# Maryvale Solar Farm

SSD 8777  
Response to Submissions

5 February 2019

Figure 1-1 Overview of Project and Site Constraints

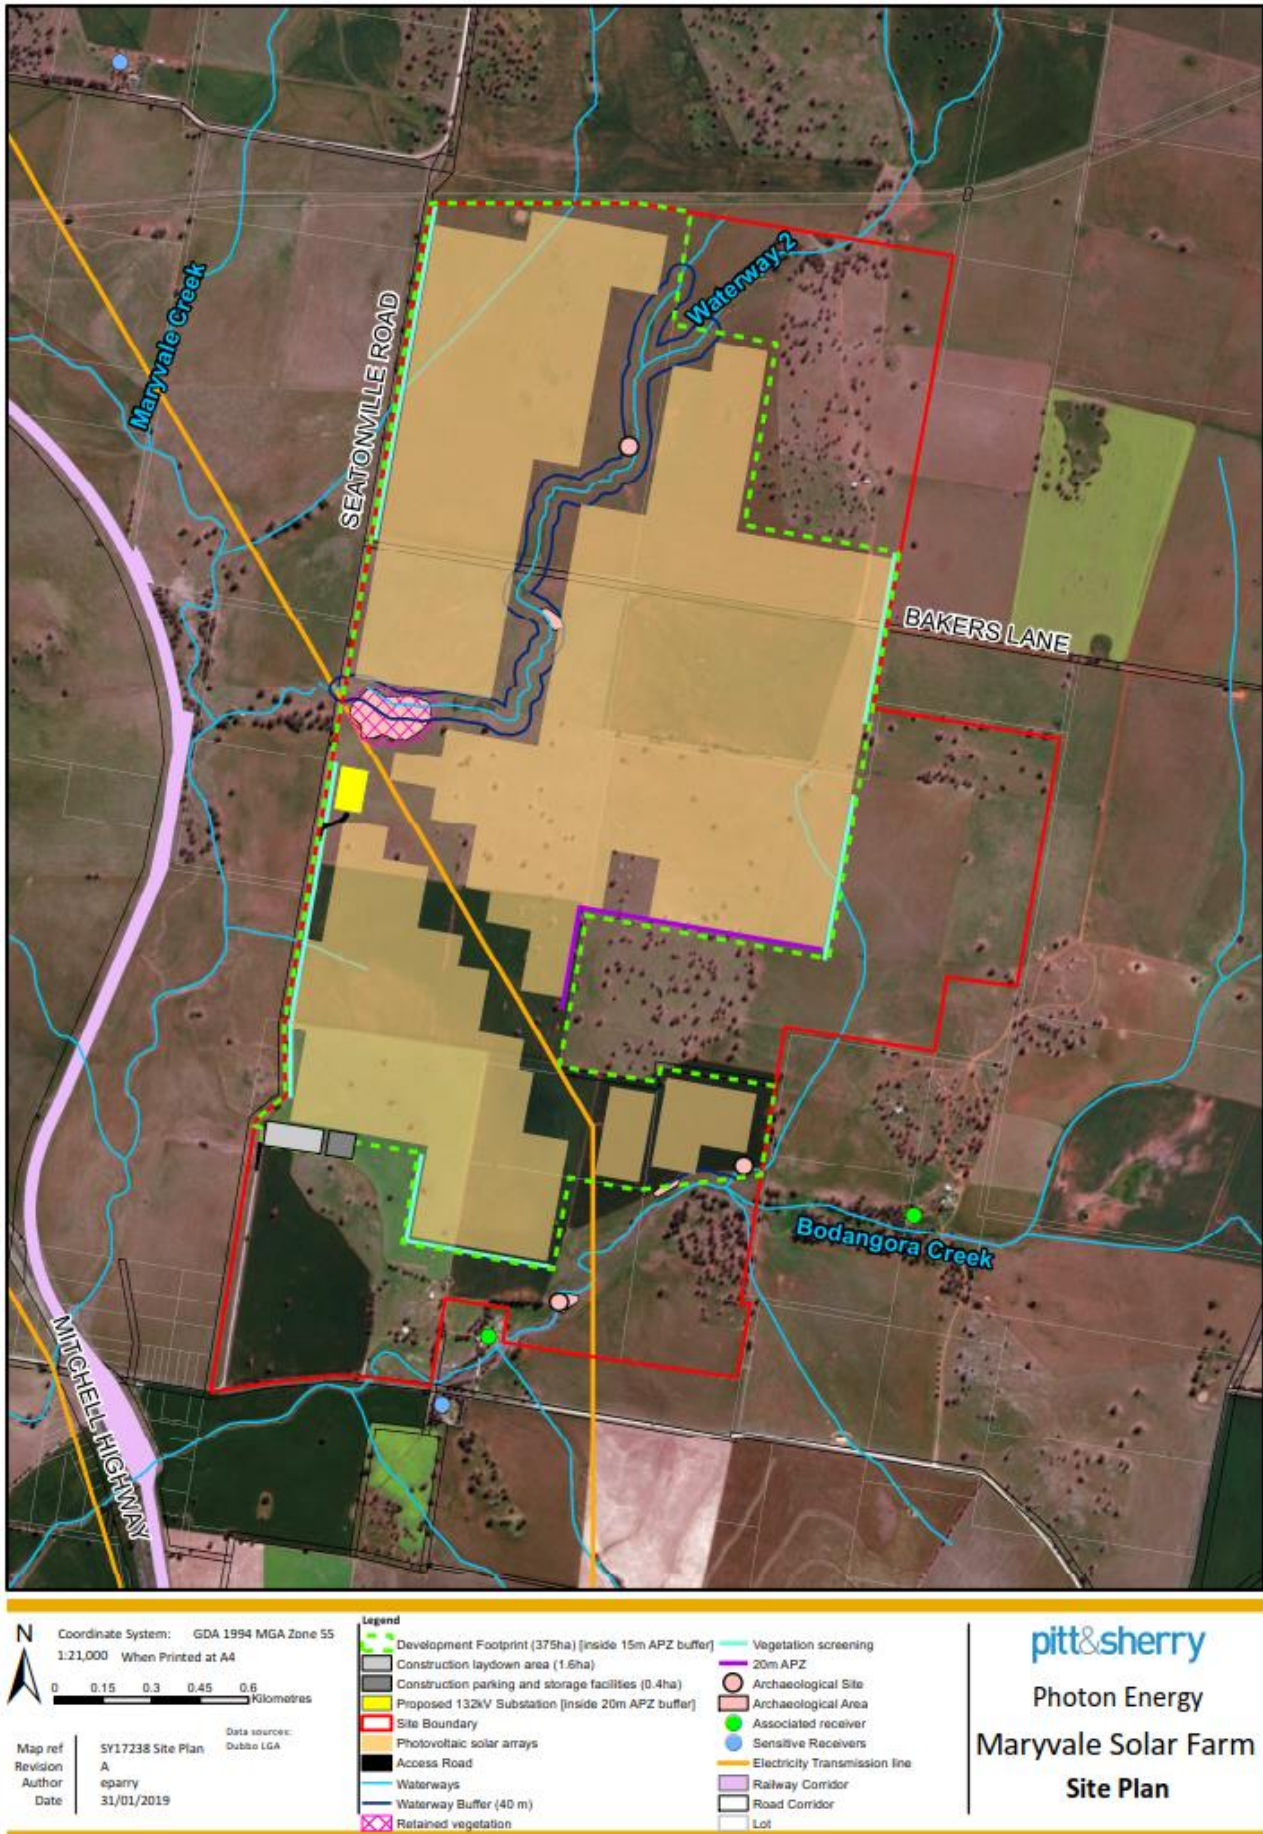
Further consideration of the design has identified that up to five crossings for cabling may be required across Waterway 2. The cabling would connect the solar panels separated by Waterway 2 and its associated 40m buffer (see Figure 1-1). These crossings may be above ground or below ground (requiring trenching). The crossings would be located outside of the identified Aboriginal archaeological sites and would avoid the area of native vegetation to be retained in the west of the site. The depth of any trenches will be determined based on the depth of the waterway at the selected location. The height of any above ground crossings would be equal to or less than existing electrical infrastructure on the Site.

Figure 3-1 Land subject to development shown in green and the revised subdivision of the Site

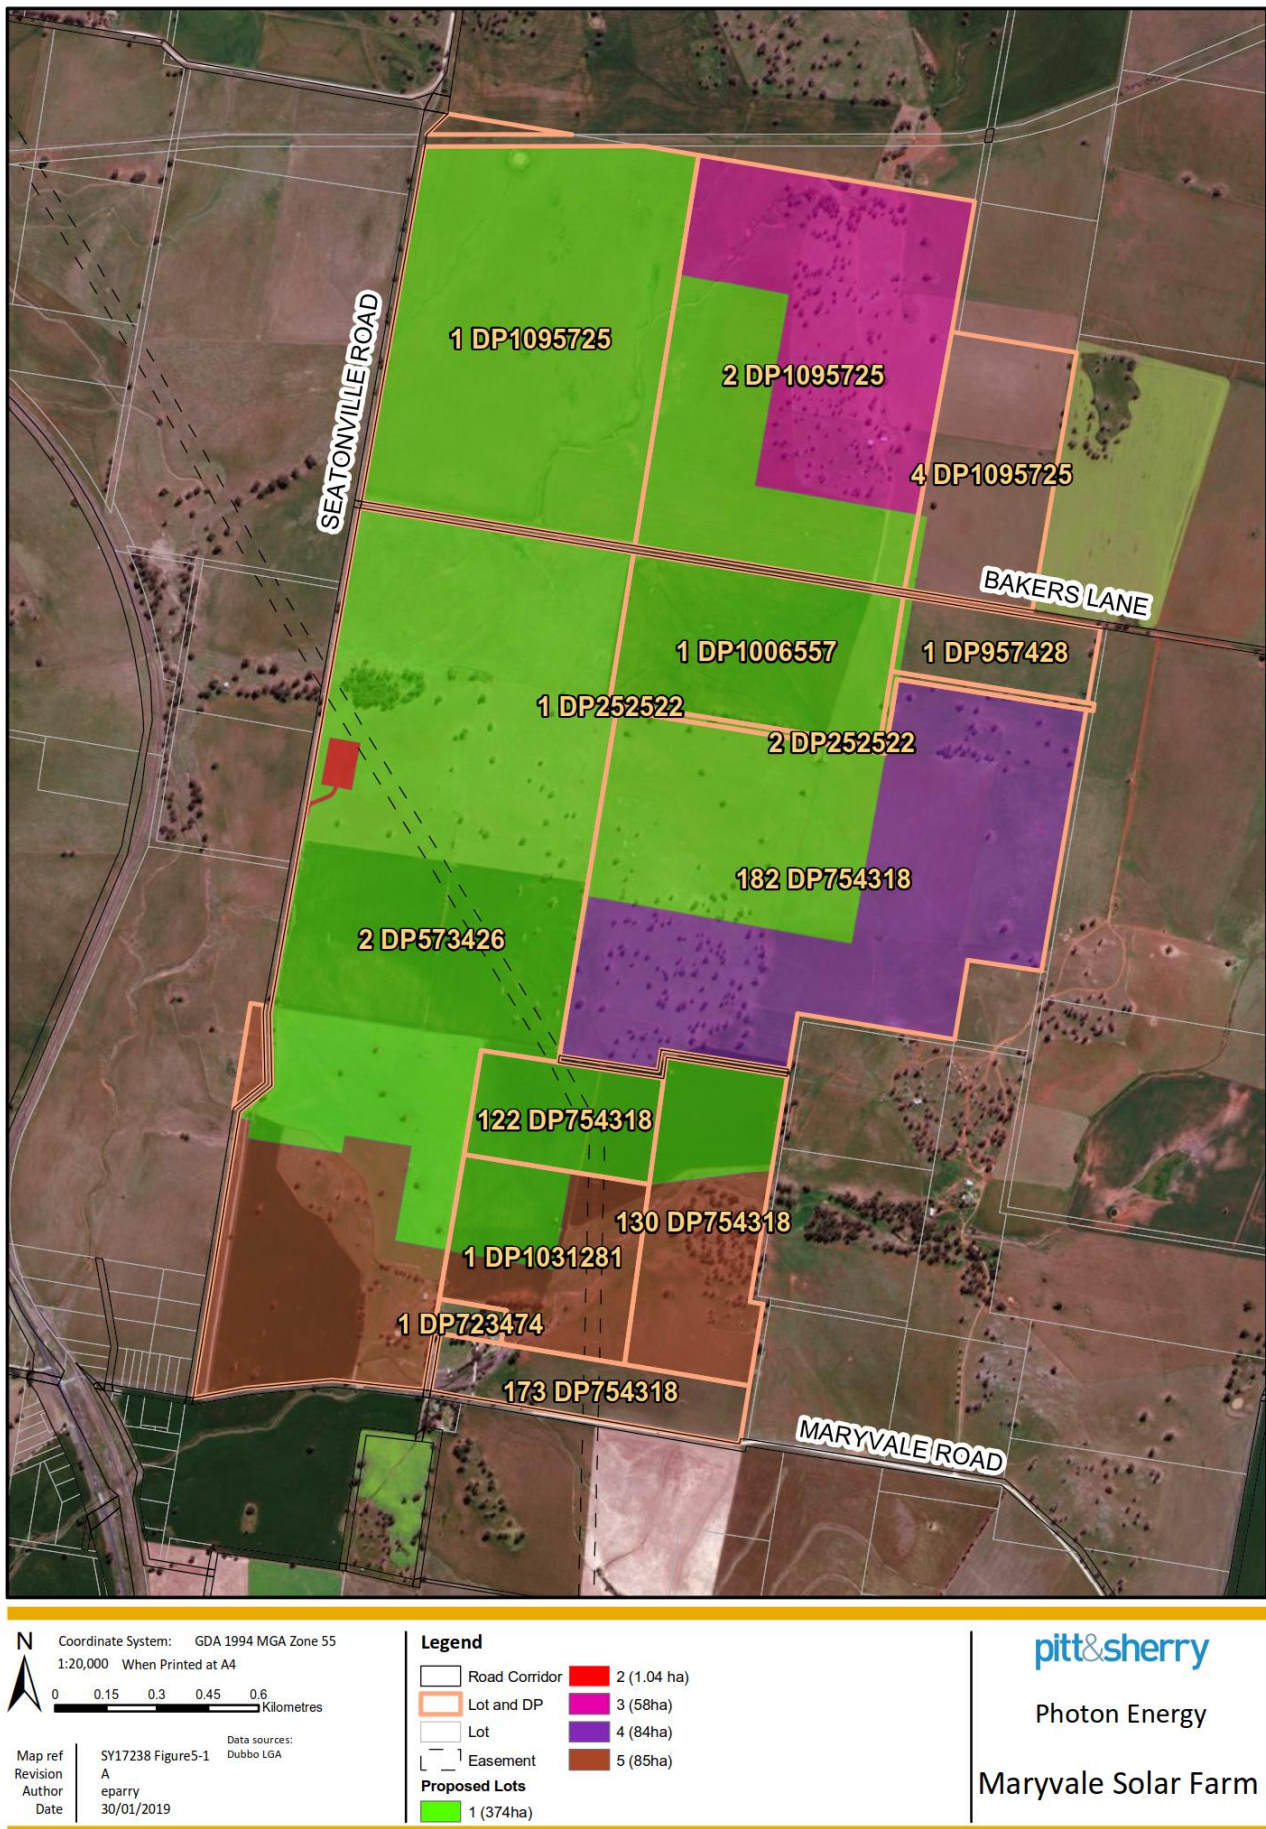
Changes are proposed to the area for the substation and subsequently a revision to the proposed subdivision as presented in the EIS.

MSF propose to change the size of the area the new substation would occupy from approximately 60m x 80m (0.48 ha) as outlined in section 3.3.1 of the EIS, to an area of 90 m x 115m (1.04ha). The area of the substation includes the 20m Asset Protection Zone (APZ). The increased area of the substation will not result in an increase in the development footprint of the Proposal. The location of the substation has not changed as shown in Figure 1-1.

The substation requires a subdivision to provide a separate lot to be owned by TransGrid. The subdivision for the substation will have a small overlap with transmission line easement to provide a connection to the 132kV power line. The substation will also have a dedicated access easement into the substation from Seatonville Road.

A map showing the proposed subdivision lots is shown in Figure 3-1. Due to the change to the subdivision area for the substation, a revised subdivision outline is shown in Table 3-1 with the updated areas of proposed lots 1 and 2.
